Moonshine Creek Fish Passage Planning and Design Professional Engineering Services

RFP NO. 2025-07/444-025

Response to Requests for Clarification:

Photo 4. Moonshine Creek culvert looking downstream, August 7, 2025.

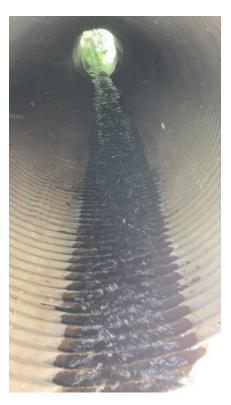
16. Can you provide photos of the culverts?
